UNITED STATES PATENT AND TRADEMARK OFFICE

10/723,248

Office Action Summary

DETAILED ACTION

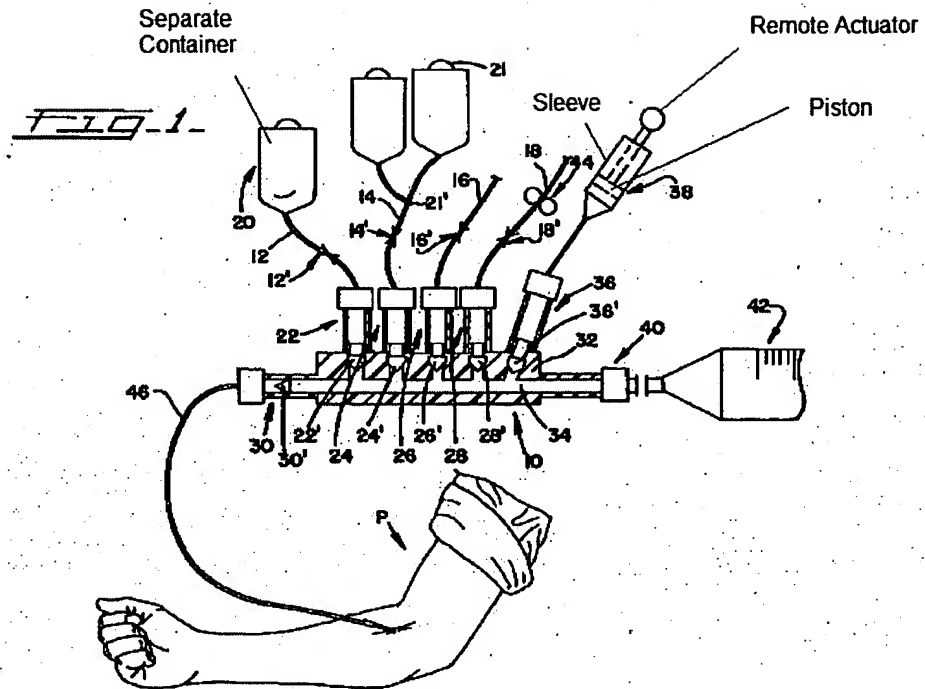
Bischof et al. disclose an implant material injection system comprising: a pressure driver (Fig. 1 below) and a separate container (Fig. 1). The pressure driver

(Fig. 1) comprises a piston (Fig. 1) and a sleeve (Fig. 1). The system comprises a means for remote actuation (Fig. 1). The remote actuator is connected to the pressure driver (Fig. 1). The actuator is capable of movement that would correspond 1 to 1 with movement of the piston (Fig. 1).

Kline discloses the remote actuator comprising first and second grip portions (Fig. 3 below) in order to give the handle good fidelity and allow the operator to feel resistance that the end is feeling (column 1, lines 28-31); and a cable (or remote connection) (Fig. 3) set within a housing (Fig. 3) connecting the actuator and the pressure driver (Fig. 19 below), in order to move the piston and create a suction in the pressure driver and allow for withdrawal of fluid (column 6, lines 32-34).
